# Waterfront - Main Corridor

## Meeting Summary

This was the Seattle Design Commission's (SDC) sixth review of the Waterfront – Main Corridor project. The purpose of this meeting was to review the design development stage of the Waterfront – Main Corridor project. During prior meetings to review the concept and schematic design phases, the project was divided and reviewed in two segments- Corridor North of Union St and Corridor South of Union St. The entire corridor was reviewed over a two-day period during the design development phase.

Design Development

Figure 2: Proposed paving plan (top), detailed intersection paving plan (lower left), and detailed promenade paving plan (lower right)

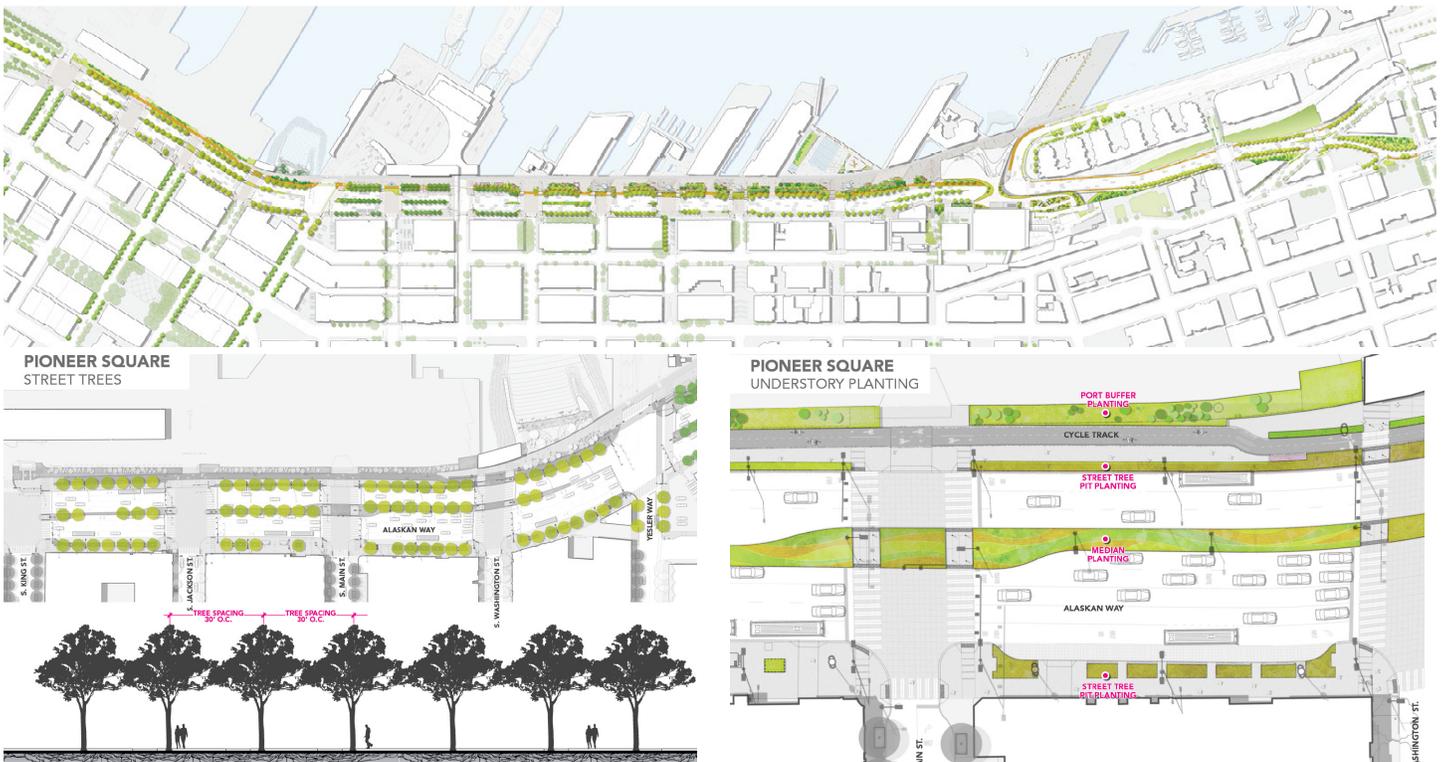
The SDC commended the project team for providing a well thought out and engaging paving design. Commissioners appreciated the quality and color of the proposed materials, all of which seemed to be appropriate for the corridor. The Commission also appreciated the attention to detail given to the design of the pedestrian areas, specifically in how the design provides visual cues when transitioning between different environments.

The Commission appreciated the use of pedestrian scaled pavers within the intersections, but recommended the project team pay attention to the color contrast between the concrete and pavers at each intersection. Commissioners then recommended the project team consider graduating the spacing of concrete banding on the bicycle pathway as it approaches each pedestrian crossing. The SDC also recommended the project team consider adding edge striping on the proposed cycle track to increase safety for cyclists.

Commissioners then encouraged the project team to specify a neutral color for the metal warning strip that provides enough contrast from the surrounding paving for visually impaired users. Commissioners also appreciated the treatment of parking bays with different paving materials from vehicular travel lanes.

The SDC then commended the project team for providing a mockup of different paving areas. As a result of viewing the mockup, the Commission recommended the project team pay attention to details in creating lettering on the concrete sections to ensure the longevity of their legibility.

The SDC recognized the project itself, which will promote cycling and pedestrian movement along the waterfront, as well as the high quality of proposed paving materials, as a significant part of the sustainability strategy. The Commission voiced its potential concern with the longevity of the aggregate concrete and recommended the project team pay close attention to how the concrete with larger aggregate is treated and maintained so to limit the amount of unwanted aggregate loss.

1. Pay attention to the color contrast between concrete and pavers at intersections
2. Pay attention to detail in creating lettering on concrete sections to ensure the longevity of their visibility
3. Provide guidelines of expectations for repairing and replacing utilities beneath the waterfront project
4. Pay attention to how the aggregate concrete is treated and maintained so to limit amount of unwanted aggregate loss.
5. Consider graduating the spacing of concrete banding on bike pathway as it approaches pedestrian crossings
6. Consider adding edge striping on the cycle track for safety, particularly in proximity to the steel walls

Figure 3: Illustrative planting plan (top), and examples of detailed street tree and understory planting plans (bottom)

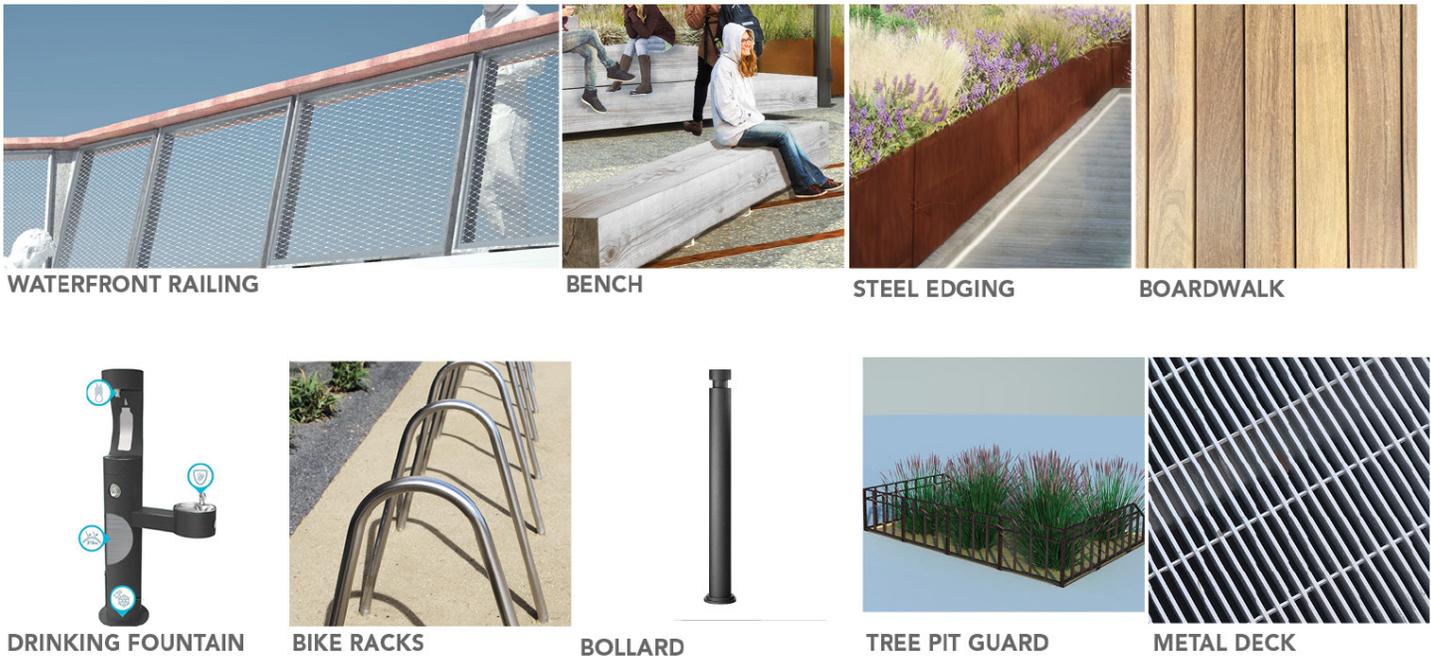
The SDC had differing opinions on the consistency of street trees throughout the corridor. While endorsing the idea of using multiple species, several Commissioners desired to see more consistency along Alaskan Way to make it feel more like a boulevard, while other Commissioners thought the using different varieties of street trees in each block helped delineate the different neighborhoods along the corridor. The SDC recommended the project team consider the degree to which continuity of tree species along the corridor is appropriate.

The SDC commended the project team for using soil cells along the corridor and strongly recommended that soil cells not be excluded from the final design. Commissioners appreciated that soil cells would not be located beneath the roadway and cautioned the use of soil cells below all vehicular zones.

The SDC agreed with the placement of understory planting. Commissioners requested more information about how different plant species will work together within the same planting area. The Commission then discussed ways to provide information about ethnobotany, the historical use of native plants by native peoples. The SDC recommended the project team explore ways to explain ethnobotany and to consider creating native plant communities. Commissioners also recommended the project team find an appropriate balance between the use of signage and other educational platforms to explain ethnobotany.

1. Consider the degree to which continuity of tree species along the corridor is appropriate
2. Continue with the use of soil cells and high quality soil mixes, which the SDC strongly endorses
3. Explore ways to explain ethnobotany, the historical use of native plants by native peoples and consider creating native plant communities. Find an appropriate balance between the use of signage and other educational platforms.
4. Use plantings to express the seasons

Figure 4: Proposed furnishing palette for the main corridor

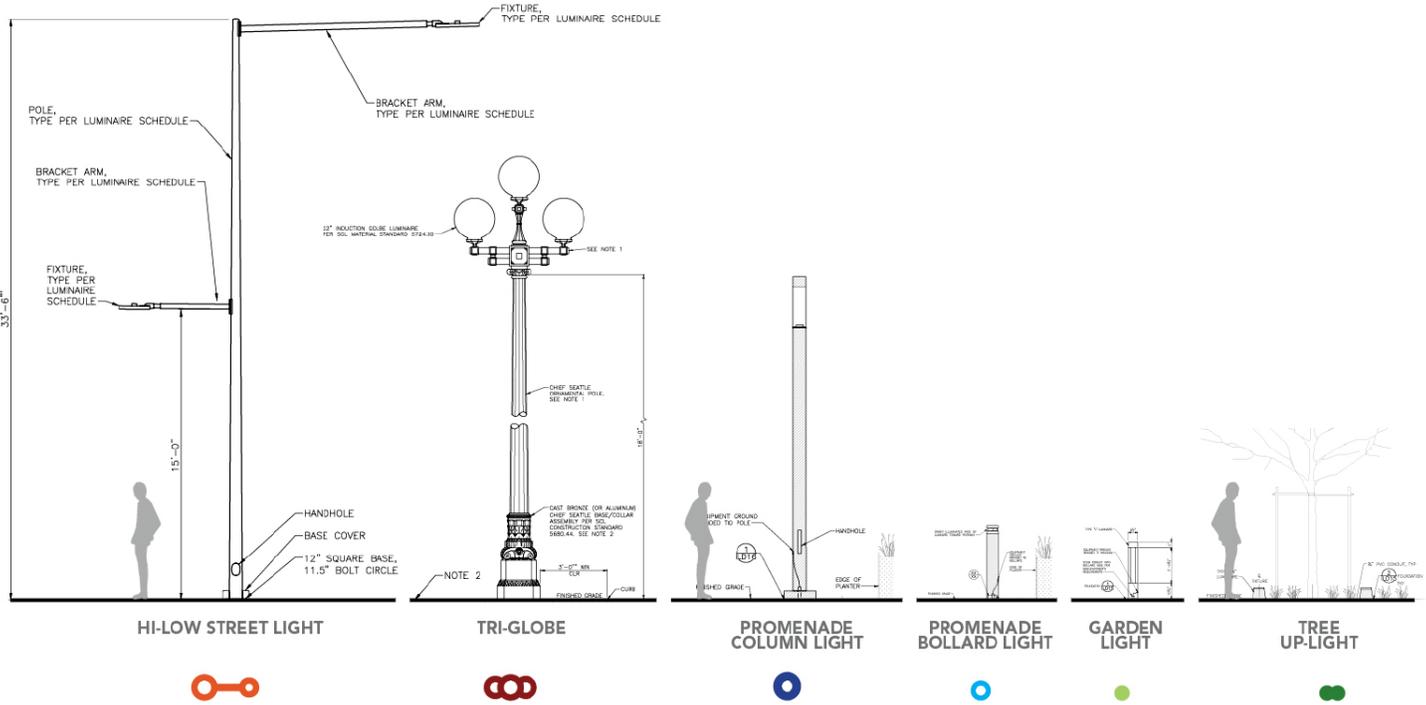
The SDC appreciated the openness of the railing design. The Commission then commended the project team for reusing Ekki wood for the top rail. The SDC then strongly recommended the team maintain, to the degree possible, the weathered texture while reusing Ekki wood for railing.

The SDC appreciated the proposed design and material of the wooden benches. Commissioners commented that the proposed benches will be unique to the Seattle Waterfront and that they will integrate well with the adjacent wooden piers. The Commission is concerned with the lack of clarity in terms of the bench arms/dividers, which can be used to provide support for users needing assistance. The renderings show no dividers, and the detailed drawings include dividers that are far apart. The SDC recommended the benches include at least some arms/dividers that are spaced closely enough to provide support for the mobility impaired.

While the SDC appreciated the design of the steel edging, several Commissioners are concerned with potential injuries caused from coming in contact with the hard edge, specifically the vertical edge along the corners of the planters. The SDC recommended the project team increase the radius of the vertical edge along the corners of the steel edging to reduce potential injuries. The Commission also recommended the project team be mindful of the proposed height of the steel edging and how it will affect the experience of the plantings.

The SDC had differing opinions on whether to include the proposed bollards. Several Commissioners thought the bollards did not serve a critical purpose and would clutter the area. There was also a lack of clarity about whether or not these elements would need to be brightly painted or include reflective material. Other Commissioners thought the bollards could function well as a visual indicator, but recommended increasing the center width between the proposed bollards to allow for better pedestrian flow.

Although the SDC had differing opinions as to whether the proposed guard fit well with the overall context of the Waterfront development, Commissioners were concerned the guards were too tall. The Commission recommended the project team consider reducing the height of the tree pit guards and to explore the simplicity of the design, understanding how the proposed tree pit guards relate to the surrounding context.

1. To the degree possible, maintain the weathered texture of the Ekki wood when reused for railing
2. Include bench arms/dividers that are spaced close enough to provide support for mobility impaired
3. Increase the radius of the vertical edge along corners of the steel edging
4. Be mindful of the proposed height of steel edging and how it will affect the plant experience
5. Consider providing more bicycle racks throughout the corridor
6. Increase the width between the pedestrian bollards to allow for better pedestrian flow
7. Highly encourage to not painting the warning strip yellow
8. Consider reducing the height of the tree pit guards. Explore simplicity of the design and understand how the guard relates to the surrounding context.

Figure 5: Proposed lighting palette for the main corridor

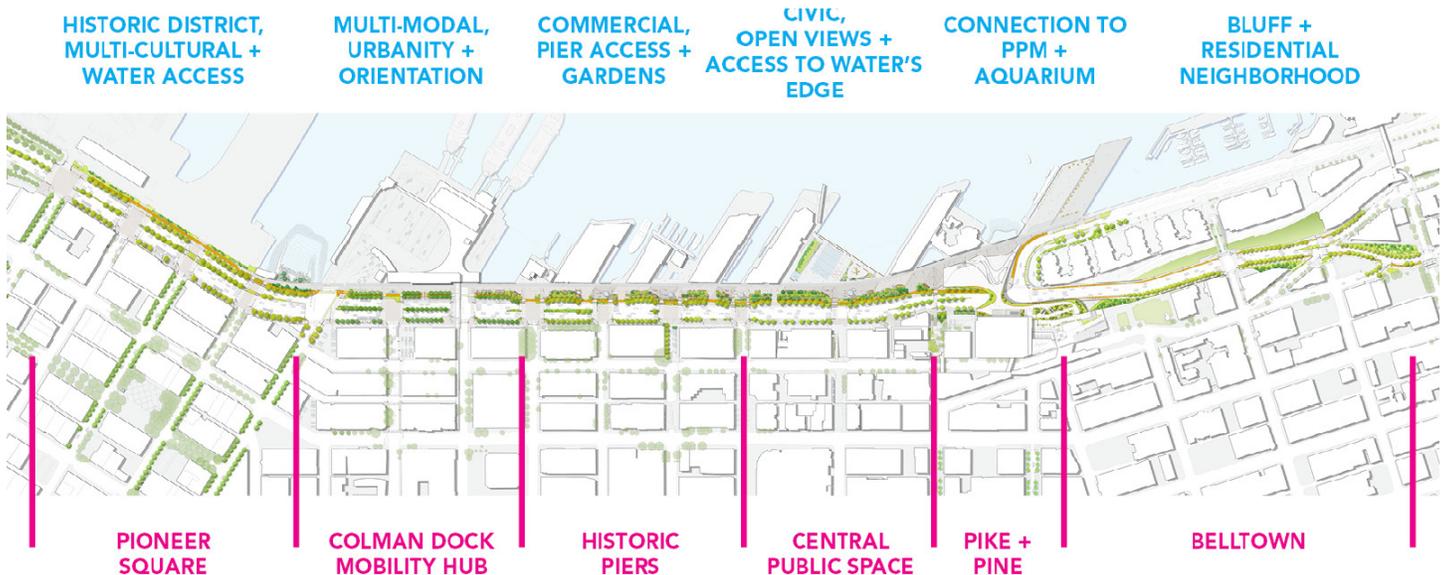
The SDC appreciated the proposed design of the roadway lighting and the consistency of the lighting fixture finishes with other project elements such as bollards. The Commission encouraged the project team to include a warmer color for the pole at the pedestrian level, if the opportunity should arise.

The SDC agreed the proposed tri globe lighting will help integrate Pioneer Square and Colman Dock Mobility Hub along Alaskan Way. Commissioners also agreed the quantity of light poles was adequate and would not over clutter the public right-of-way. Because they will serve only an aesthetic purpose and will not contribute to the lighting plan, the Commission recommended the project team minimize the lighting level of the tri-globe light.

The SDC was concerned with the proposed garden lighting. The Commission agreed there should be enough coverage to provide lighting throughout the planting areas to address safety and security issues, but disagreed with the proposed size and location of the light fixtures. While they had differing opinions on the height of the proposed fixtures, Commissioners agreed the project team should reexamine the proposed design and location of the garden lighting. The SDC recommended the project team consider providing a round bollard design rather than the proposed square shape. The commission also recommended that the project team explore the use of art as a way to provide lighting, since the lighting is more for ambiance and providing a sense of activity rather than for functionally illuminating walkways.

1. Minimize lighting level of tri-globe fixtures
2. Consider providing a round bollard for the garden lighting
3. Explore the use of art for the garden lighting
